SUBJECT: Draft Notice of Proposed Rulemaking ("NPR") for Full-Size and Non-Full Size Cribs under Section 104(b) of the Consumer Product Safety Improvement Act; Revised Draft NPR

Attached is a revised draft notice of proposed rulemaking ("NPR") for full-size and non-full-size cribs: a redline version showing changes and a clean version. The draft includes the following revisions/corrections:

Safety Standards for Full-Size Baby Cribs and Non-Full-Size Baby Cribs; Notice of Proposed Rulemaking

Figure A. Typical Test Frame

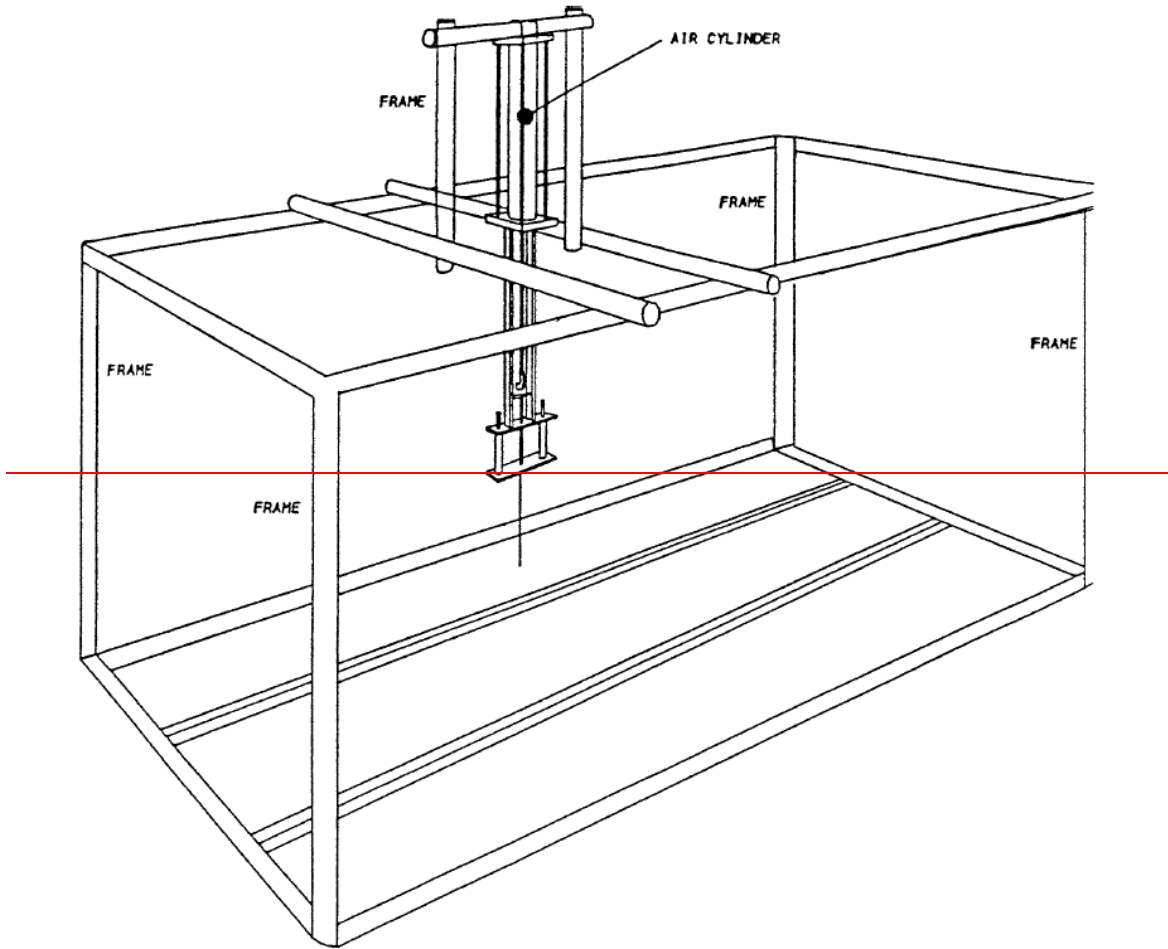
2. Changed numbers and wording for section 8.6.2.5 (p. 68 of revised draft NPR) to reflect corrections in staff memo.
3. Deleted figure A, renamed other figures, and replaced reference to figure A in 8.6.2.1 with reference to figure A1.12 which is now in final ASTM standard.

(C) 8.6.2.1 A guided free-fall impacting system machine (which keeps the upper surface of the impact mass parallel to the horizontal surface on which the crib is secured) (see Figure A~~1.12~~).

Figure **BA**. Impact Mass Shape

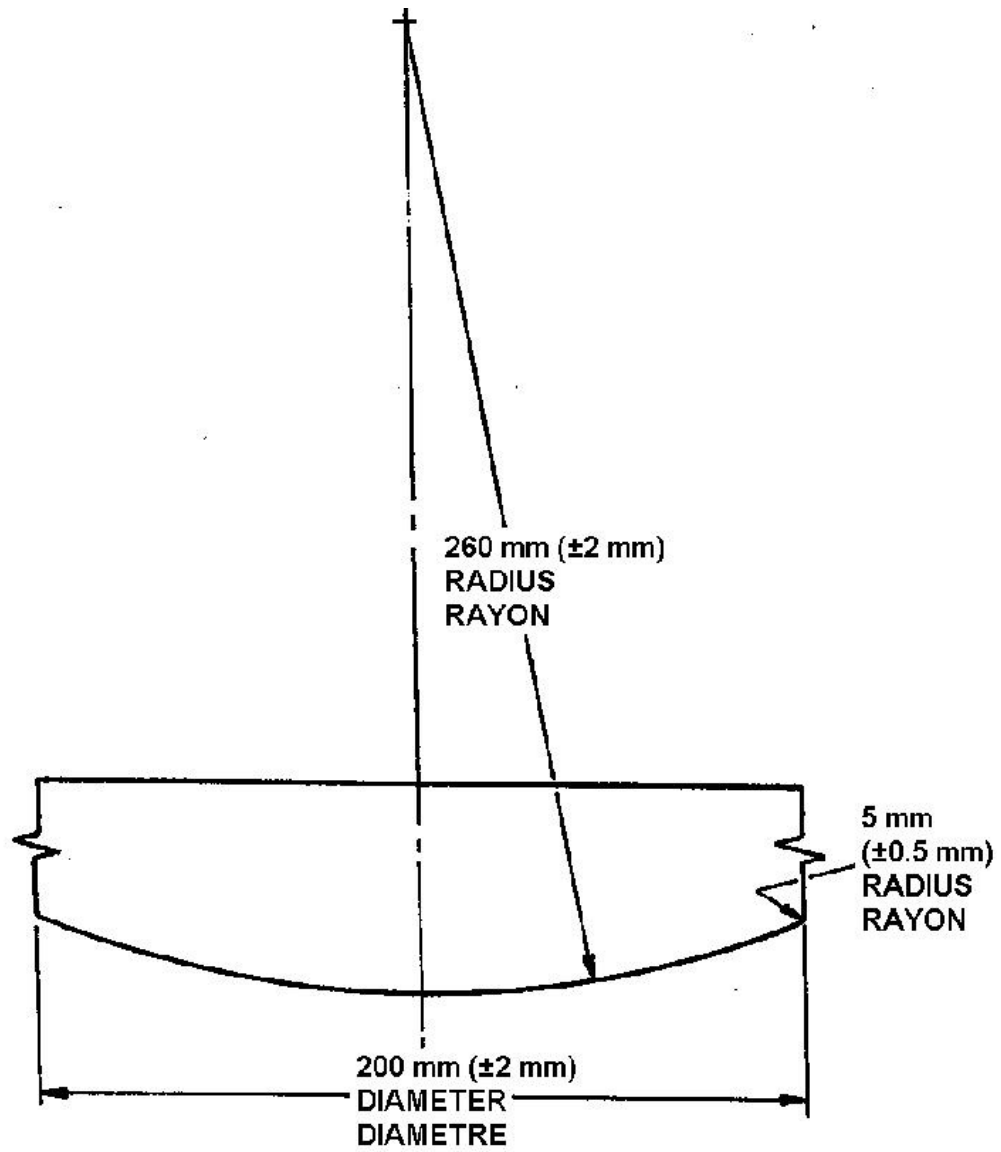
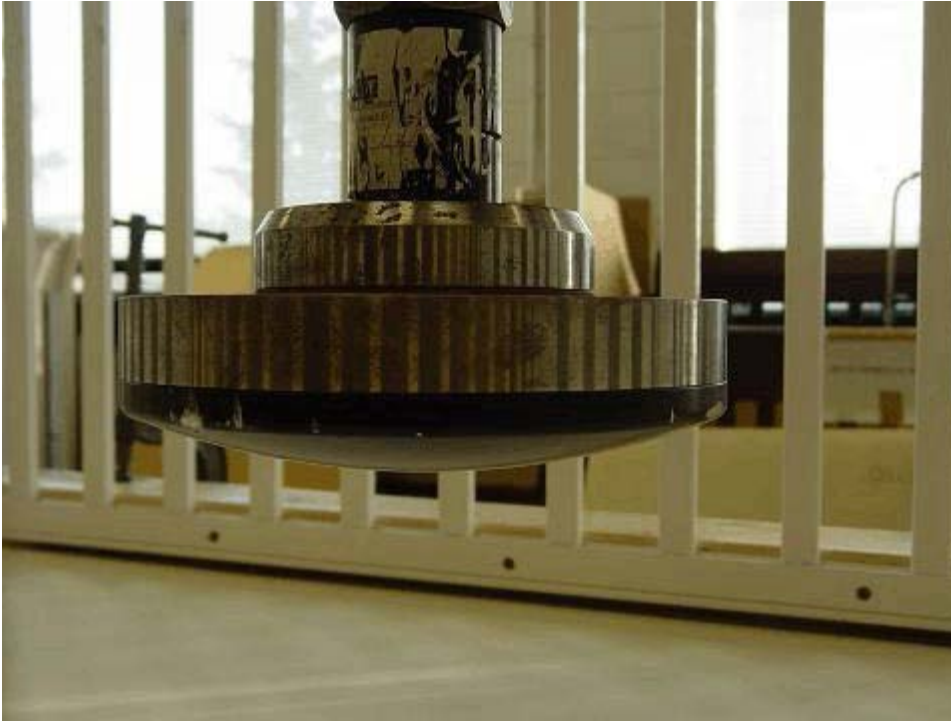
(D) 8.6.2.2 A 45 lb (20 kg) impact mass (see Figures ~~BA~~ and ~~CB~~).

Figure F. Side Latch Test

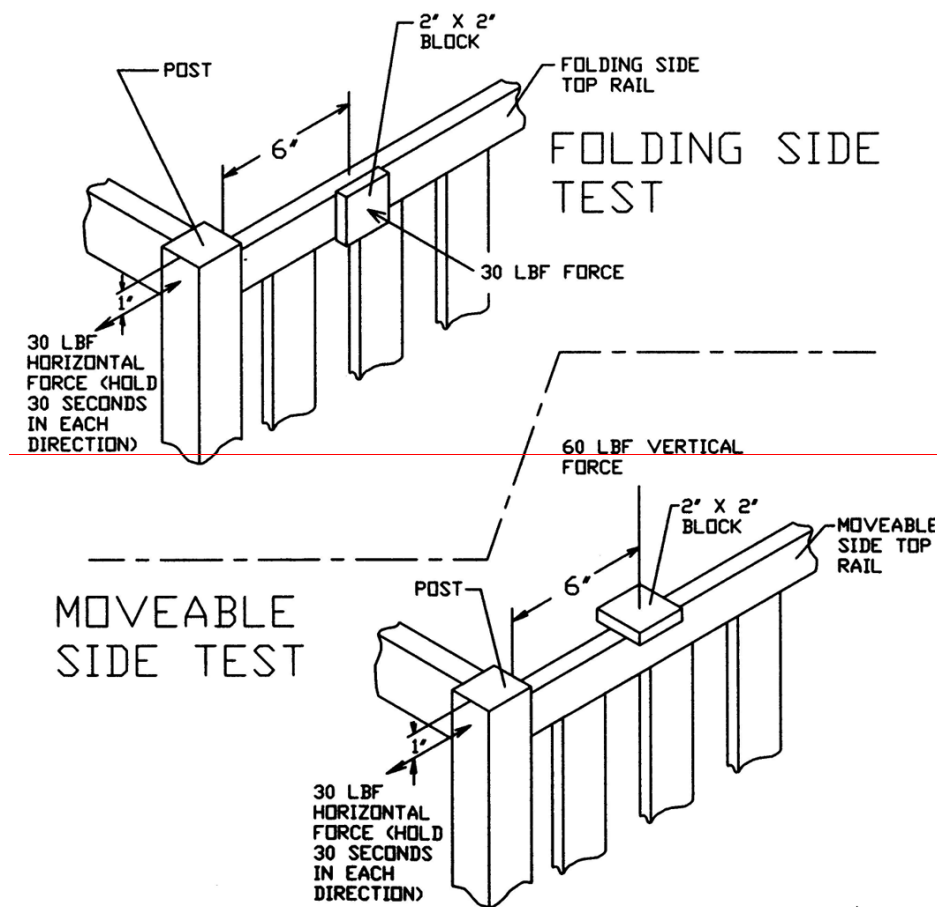
4. Deleted figure F and replaced reference to that figure with reference to figure A1.19 which is now in final ASTM standard.
5. In order to exclude provisions which relate only to play yards, added provisions stating not to comply with sections:
